**MONTGOMERY COUNTY PLANNING BOARD**  
THE MARYLAND-NATIONAL CAPITAL PARK AND PLANNING COMMISSION

RE: Abandonment Request No. AB-773  
Portions of Westbard Avenue and Ridgefield Road Rights-of-Way  
2016 Westbard Sector Plan

MCPB No. 19-032  
Preliminary Plan No. 120170170  
**Westwood Shopping Center**  
Date of Hearing: March 14, 2019

MCPB No. 19-033  
Site Plan No. 820180190  
Westwood Shopping Center  
Date of Hearing: March 14, 2019

- **Green Roof Treatment Train:**

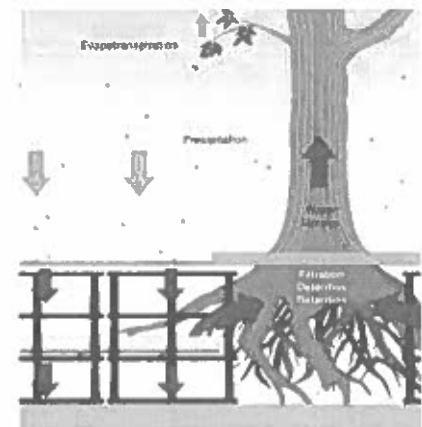
The stormwater management plans call for 430 square feet of green roof. Although, a green roof is an excellent green technology and good for reducing the heat index and also reducing cooling and heating costs for the building, it does not allow the rain water to infiltrate the ground. However, the run-off from the green roof can be directed to one of the bioretentions. The applicant should be required to incorporate this into the roof drain plans. It doesn't add much to the total volume, but in this site, every little bit is important.
